STUDY NO. 7: RAMPING AND FLOW FLUCTUATIONS EVALUATION

7.1 Goals and Objectives - §5.9(b)(1) — Describe the goals and objectives of each study proposal and the information to be obtained

Figure 2-11. Monthly flow duration curves for the Crooked River near Prineville Gage # 14080500. Source: USGS/OWRD data

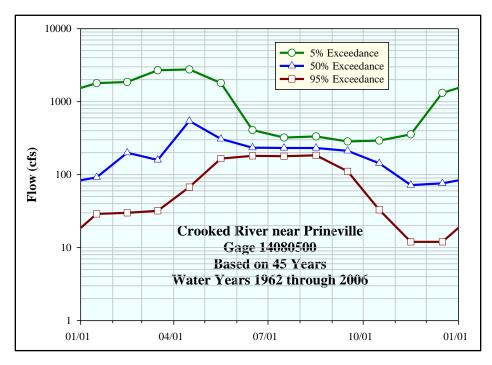
Monthly flow exceedance curves at the Prineville gage for the period of record following Bowman Dam construction are shown in Figure 2-11.
